2033 4TH AVENUE

EARLY DESIGN GUIDANCE

SDCI #3025502 / JANUARY 2019

summary of review board guidance

ALLEY SECTION BETWEEN PROJECT SITE AND YMCA APARTMENTS

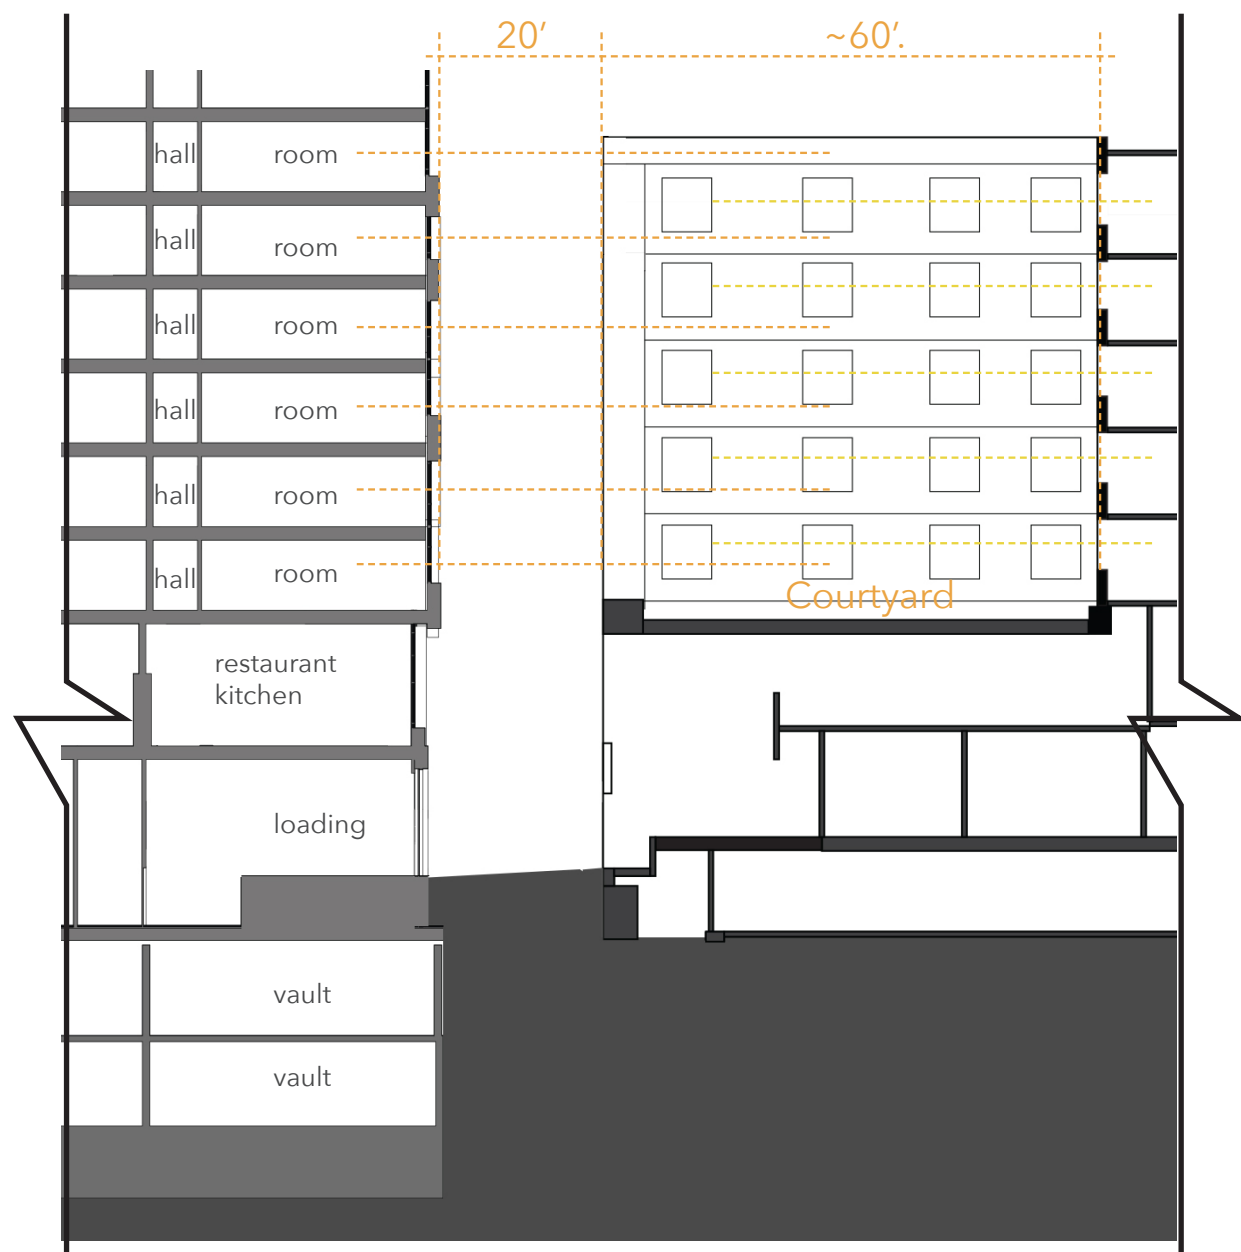
a. The Board acknowledged the publics concerns regarding privacy and requested additional information including sections documenting proposed floor levels in relation to surrounding residential properties and window mapping studies for the west and south facades. (A1.1, B1, B2)

Further study of the existing building to the south has shown that there are two small rows of non operable windows slightly stepped back within the lot line walls. The operable windows located at the center courtyard of the project are all perpendicular to the proposed project except one window that appears to be in the corridor wall and is stepped back approximately 22.5’ from the north property line. Due to the narrow width of the site, the structural core of the proposed project was not able to be moved, the updated design takes into account the building occupants access to northern light and air by proposing minor articulate in material for visual interest and enhanced air movement as well a lighter building material to help bring light down to the lower existing apartment floors.

The neighboring building to the west, across the alley, has a larger footprint with the majority of its facade facing the project site as a inset courtyard. The design team has further analyzed the existing and proposed floor lines to confirm that the project will not have direct visual access.

STREET ELEVATION - 4TH AVENUE

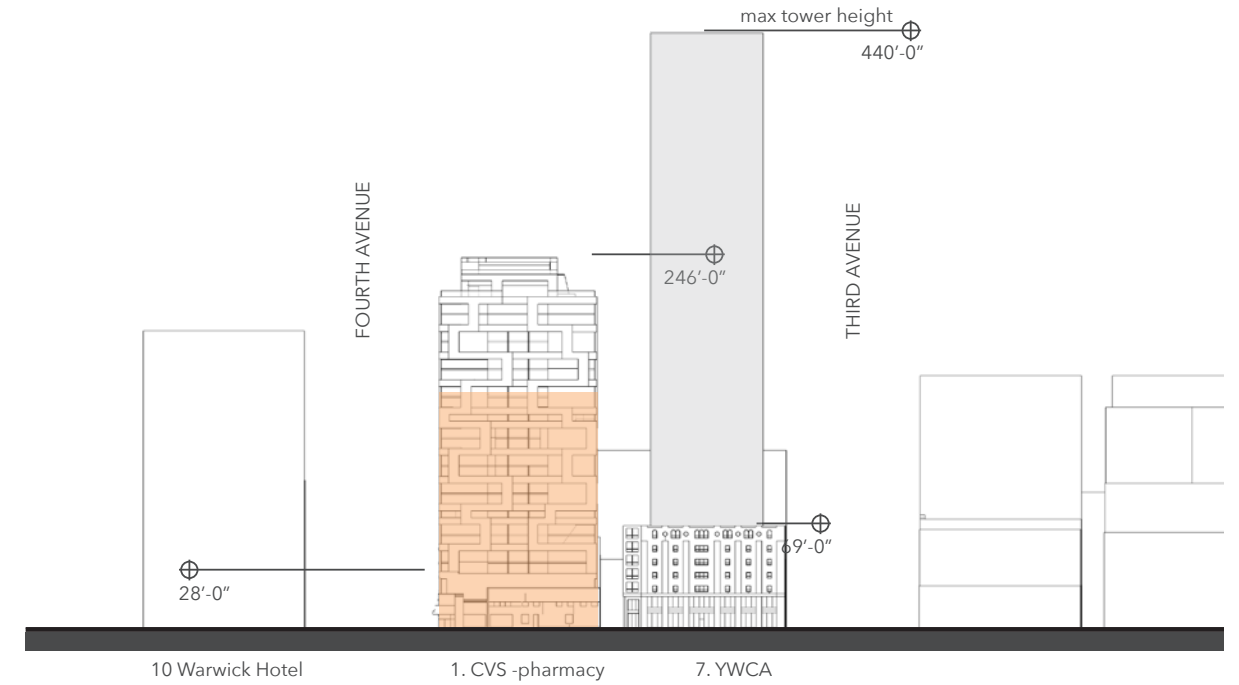
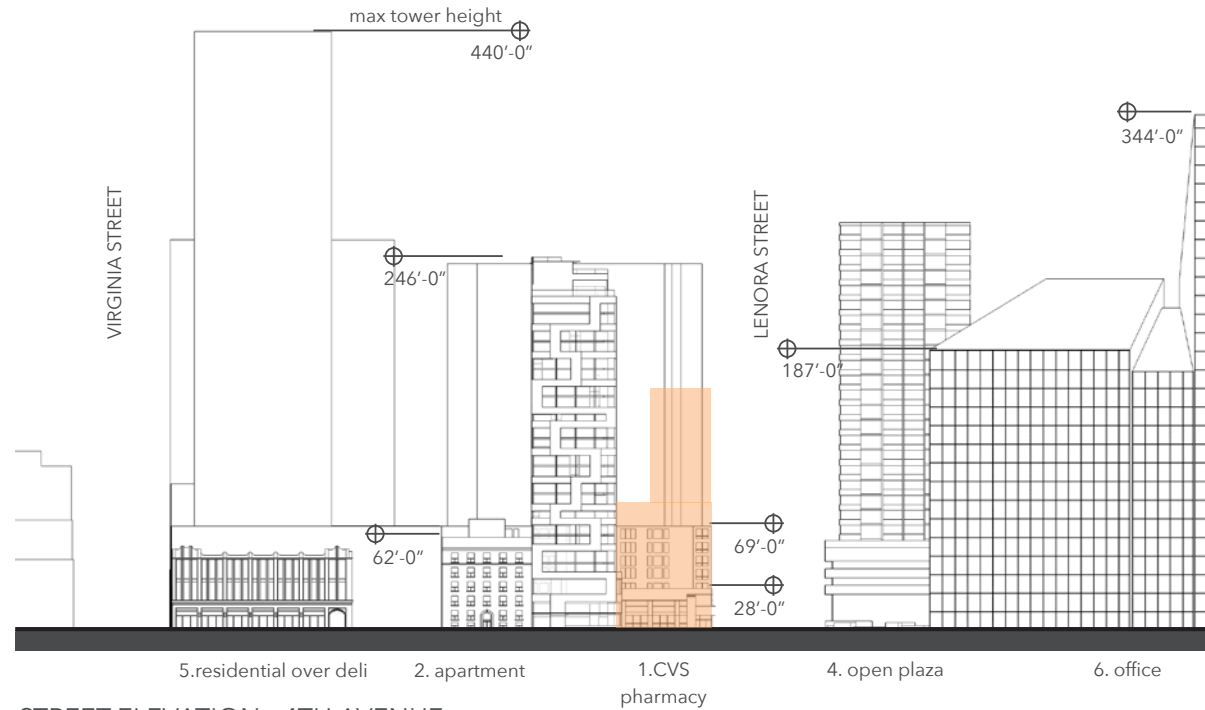
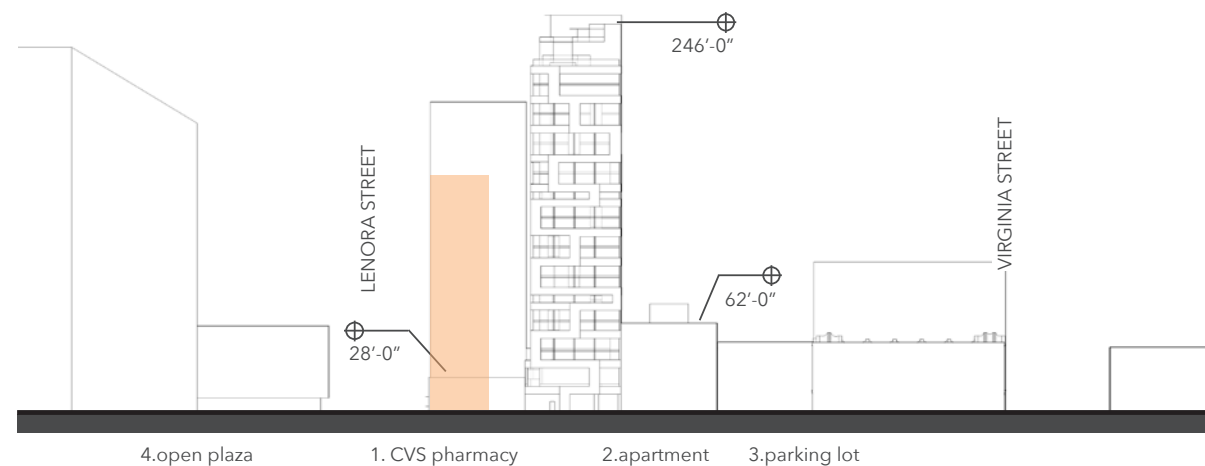
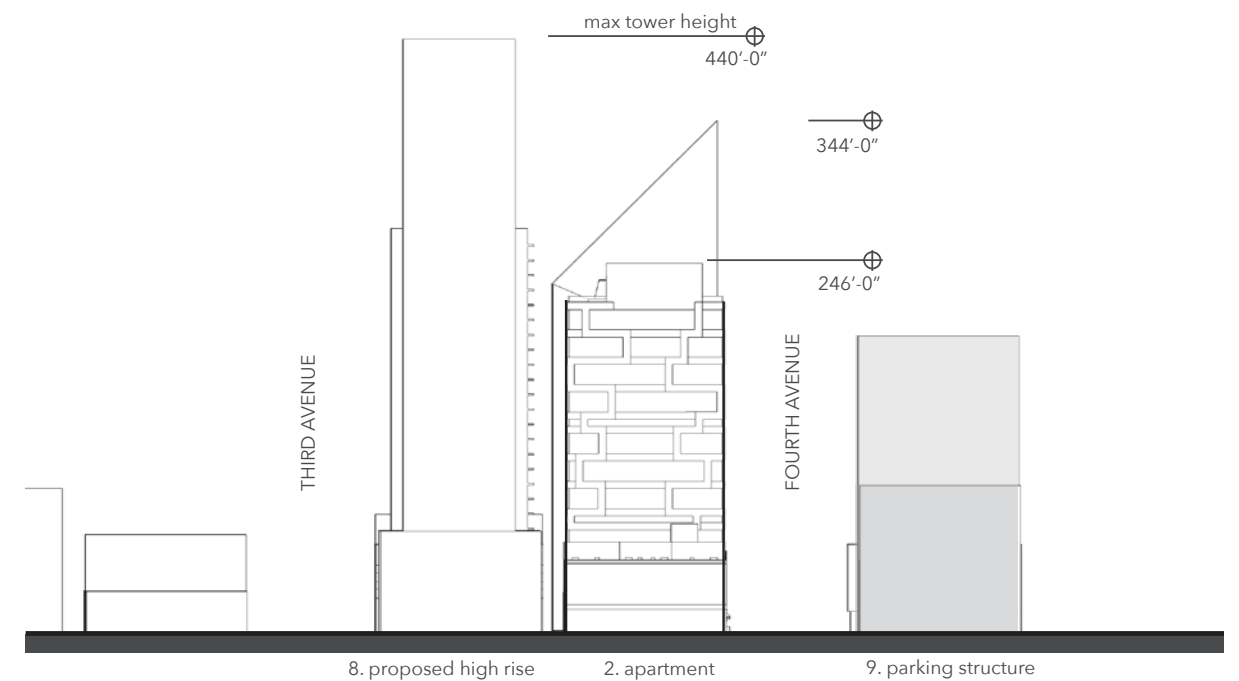
c. The Board agreed with public comment that the proposal should factor in future redevelopment and recommended a maximum zoning envelope analysis for the surrounding buildings. The Board also requested additional information on the adjacent buildings and if any have been nominated for landmark status.. (A1, B1, B2)

The design team has completed further neighborhood context analysis with sections and elevations to understand the relationship between the proposed project and its immediate surroundings. Upon further analysis, no immediate neighboring buildings have been recently nominated for landmark status.

The design team has completed further neighborhood context analysis through sections and elevations to better understand the relationship between the proposed project and its immediate surroundings. Upon further analysis, no immediate neighboring buildings have been recently nominated for landmark status but the building to the south (Stratford Apartment) is a potential landmark. The 2 story building to the north (CVS) has the potential to be developed into a tower as shown.

EDG #2 PREFERRED OPTION 3

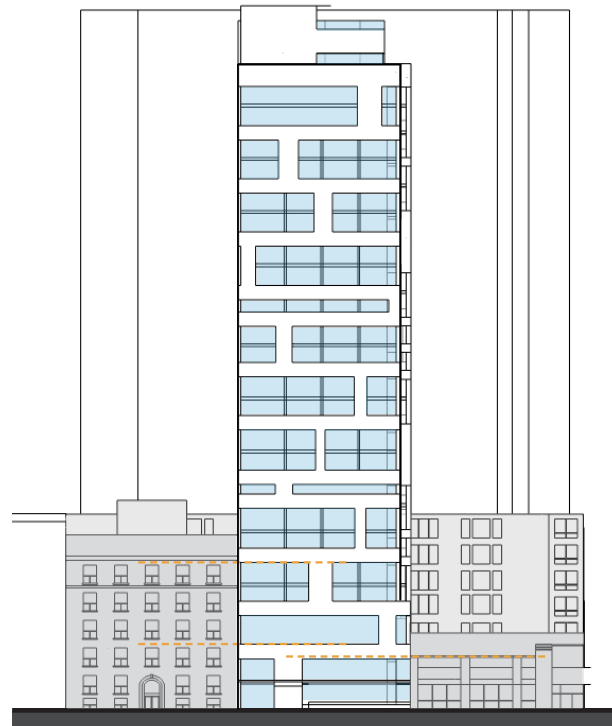
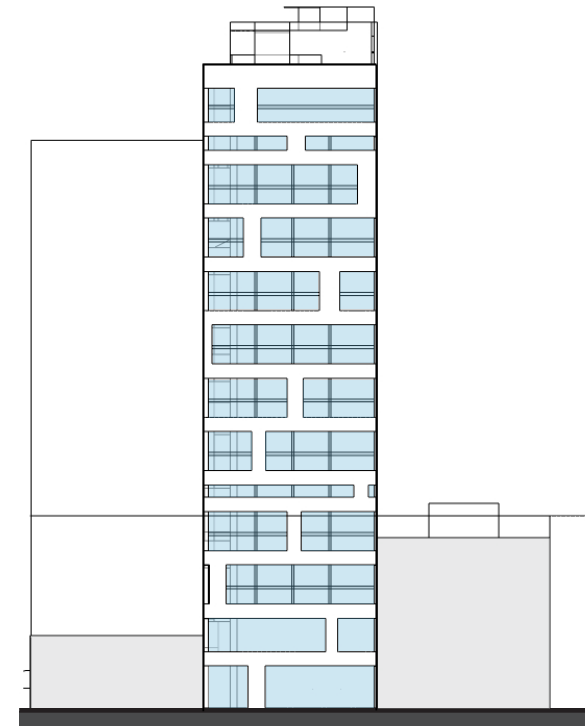
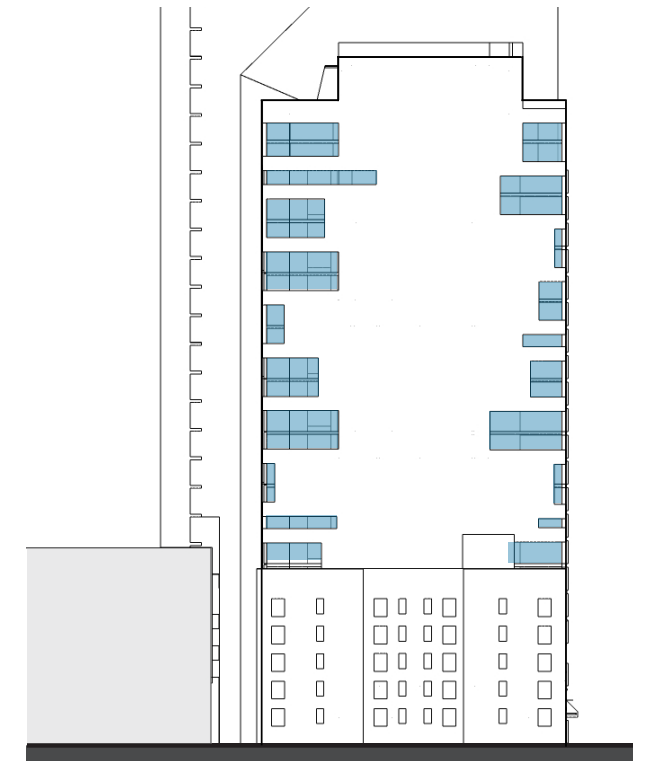
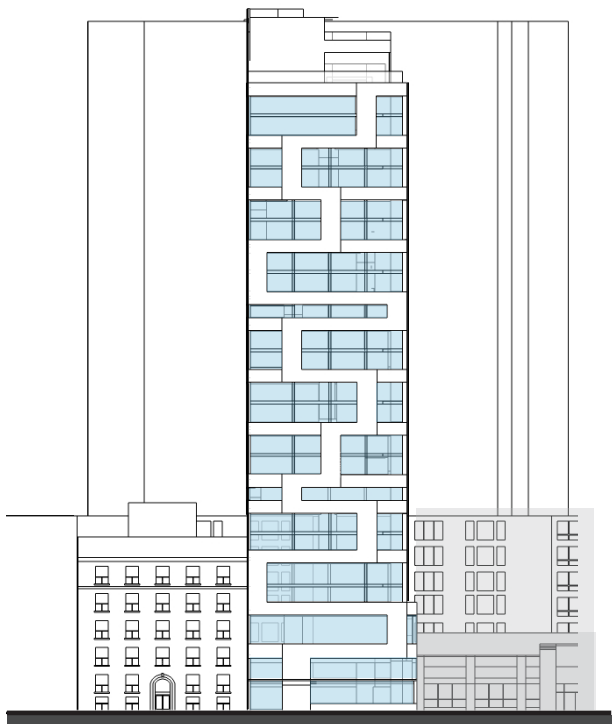
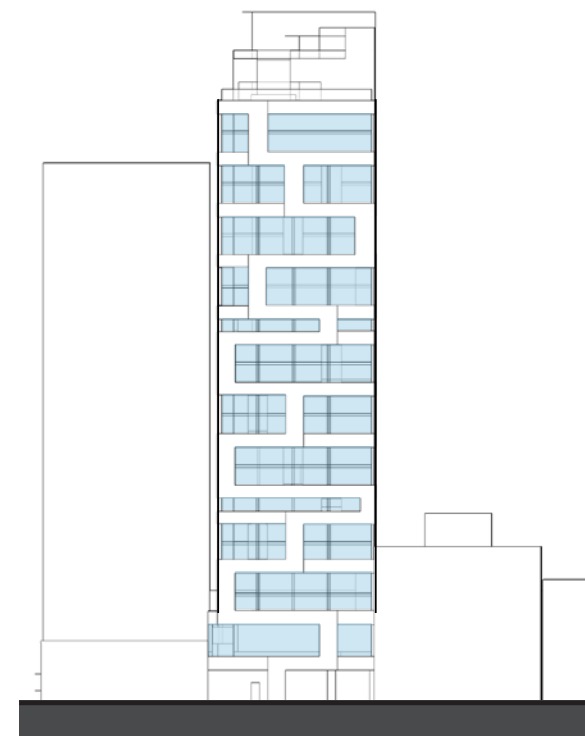
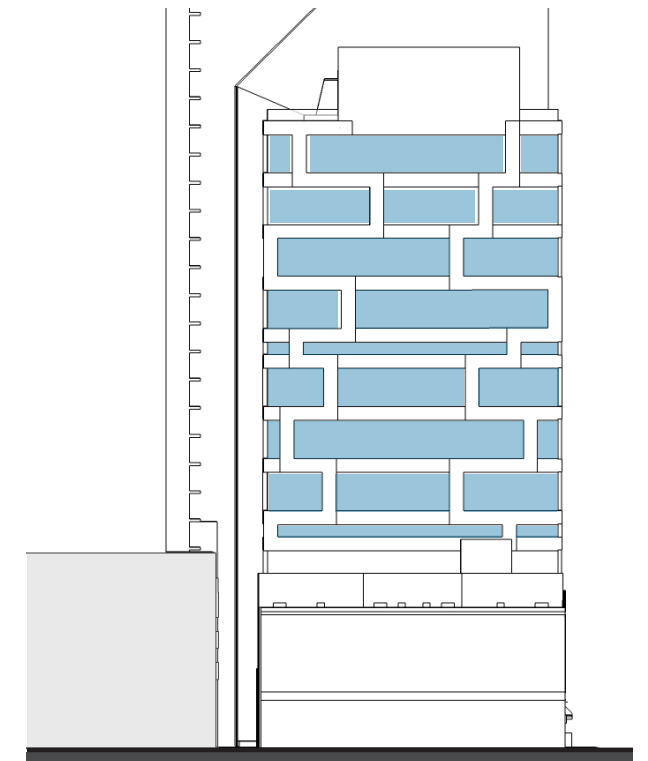
b. The Board agreed that the banding elements shown in Massing Option 3 lacked depth and hierarchy and as a result read as horizontal. To reinforce the design composition, the Board recommended carrying over the design logic of the ribbons to the north and south facades. (B1, B4, C2)

At the EDG #1 meeting, the board had concerns with the preferred concept being understandable around the entire massing. As part of the design revisions, the overall ribbon concept was strengthened by creating depth and hierarchy between the inset glazing panels, the horizontal banding and the vertical ribbon element. Additionally, the ribbon element is carried through the north and south facades, completely integrating the concept.

concept hierarchy

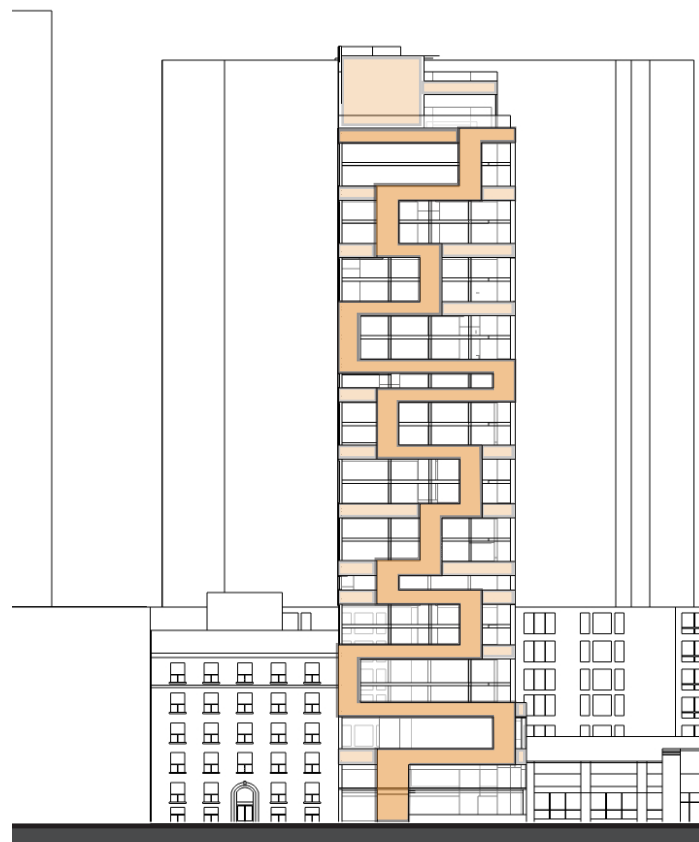
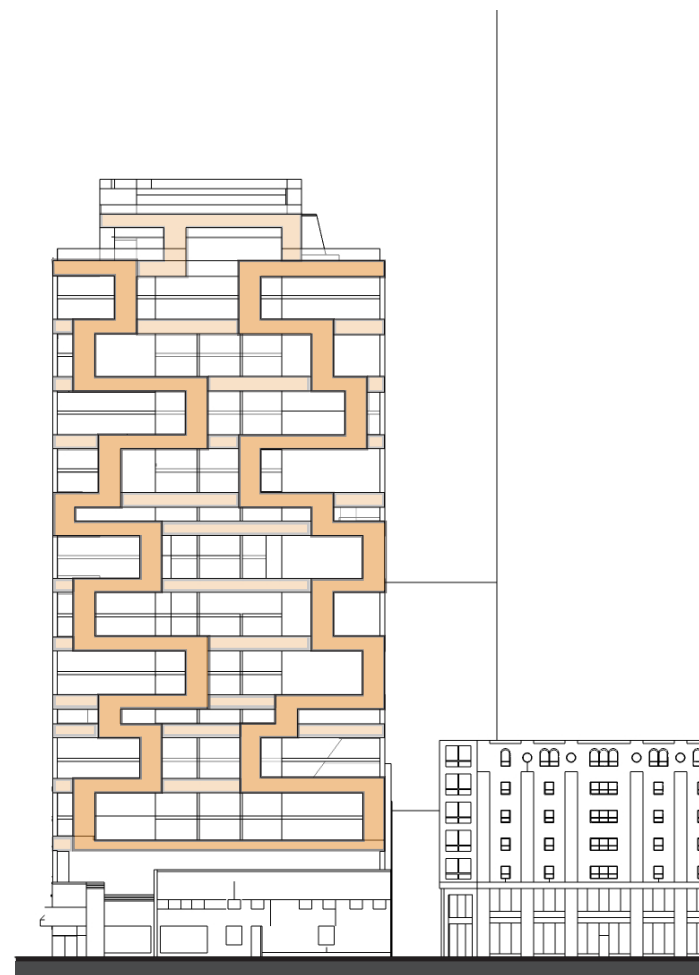
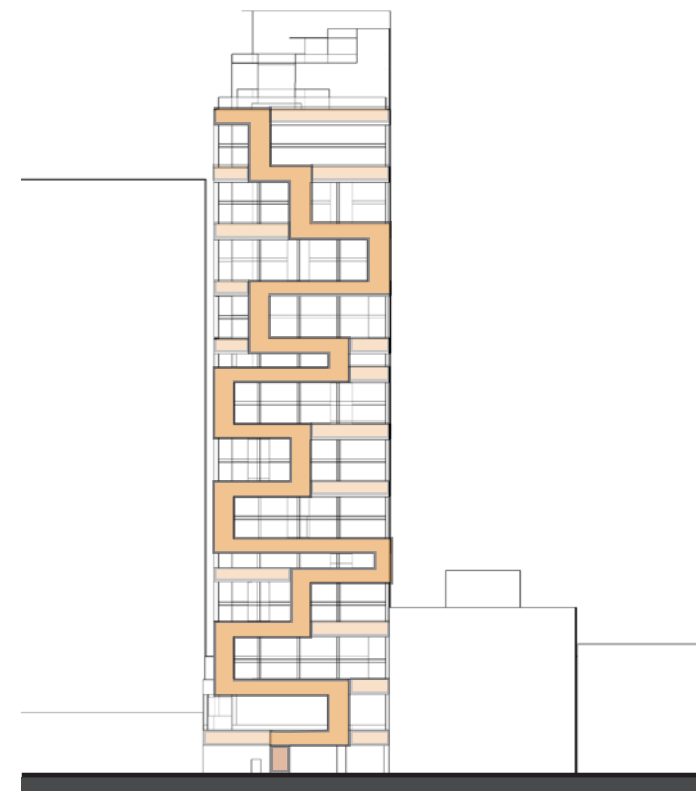
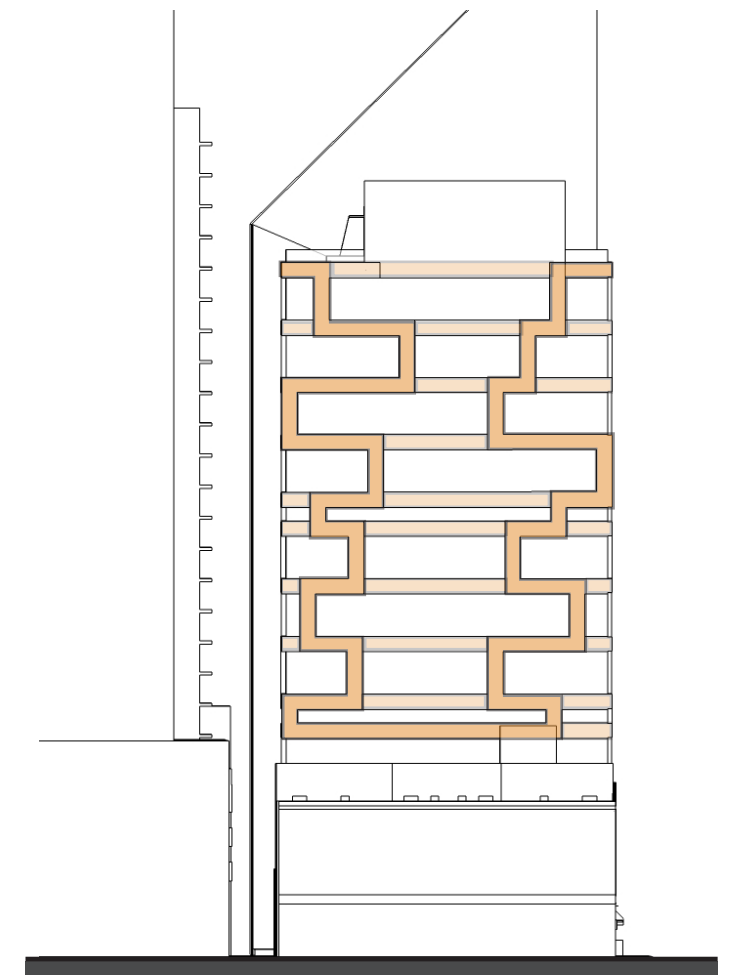
a. While the Board was supportive of the initial architectural concept, the Board was not convinced of the connection to the architectural concept shown in the massing options. The Board noted that Massing Option 1 reads as the strongest representation of the ribbon design concept as all facades are articulated. To strengthen the connection to the architectural concept, the Board recommended applying a consistent logic for the recessed ribbon elements as shown in precedent images on pages 2 and 3 of the packet. (B1, B4, C2)

The design team modified the preferred design to provide a consistent and cohesive design on all four sides of the project. Hierarchy was created using the primary ribbon element and the secondary horizontal banding and tertiary vertical banding within the volumes to create continuity around the building. The verticals are consistent widths occurring only at the demising walls of the hotel rooms. Depth and hierarchy are created by inseting a secondary glass volume separate from the solid volume, spanning 1, 2, or 3 stories, to create playful volumes.

At the first EDG meeting, the board had concerns with the preferred concept being understandable around the entire massing.
